UNITED STATES  
DEPARTMENT OF THE INTERIOR  
BUREAU OF LAND MANAGEMENTFORM APPROVED  
OMB No. 1004-0137  
Expires: January 31, 2018**SUNDRY NOTICES AND REPORTS ON WELLS**  
**Do not use this form for proposals to drill or to re-enter an  
abandoned well. Use Form 3160-3 (APD) for such proposals.**

8. Well Name and No. Toles Federal #2

**Proposed P&A NOI**  
**ConocoPhillips Company on behalf of M E W Enterprise**  
**Orphan Well**  
**Toles Federal #2**  
**30-005-62282**

**Toles Federal 2  
30-005-62282  
ConocoPhillips Company  
July 15, 2025  
Conditions of Approval**

**PROPOSED**  
**Wellbore Diagram**

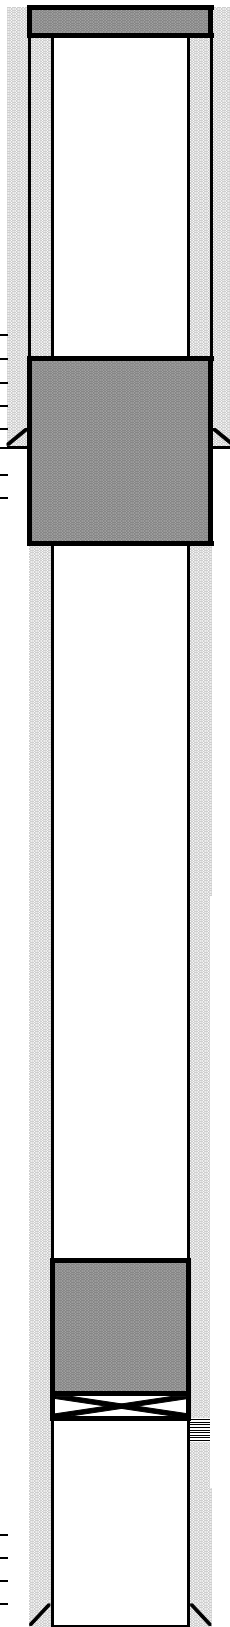
**Plug #3:** Perf & Squeeze 49 sxs cmt @ 100' & circulate to surface.  
(38 sxs outside, 11 sxs inside)

**Plug #2:** Perf & Squeeze 127 sxs class C cmt w/ 2% CaCl @ 1,050-775'. WOC & tag (Yeso, Glorieta, & 8 5/8" Shoe)  
(104 sxs outside, 23 sxs inside)

**Plug #1:** Set 4 1/2" CIBP @ 2,896'. Spot 47 sxs class C cmt w/ 2% CaCl @ 2,896-2,280'. WOC & Tag. (Abo & Tubb)

- 1. Operator shall place a CIBP at 2,896' (50'-100' above top perf) and place 47sx of Class C cement on top as proposed. WOC and TAG.**
- 2. Operator shall perf at 1,050' and squeeze class C cement to 763' to seal the Glorietta Formation and the 8-5/8'' shoe. WOC and TAG. Tag must be a minimum of 50' above the 8-5/8'' shoe.**
- 3. Operator shall perf at 100' and squeeze cement class C cement to surface.**
- 4. Dry hole marker must be below ground.**
- 5. Surface reclamation will need to be completed once the well bore has been plugged. Please contact [rflores@blm.gov](mailto:rflores@blm.gov) for additional information.**
- 6. See attached for general plugging stipulations.**
- 7. See attached for New Mexico Oil Conservation Division's plugging guidelines.**
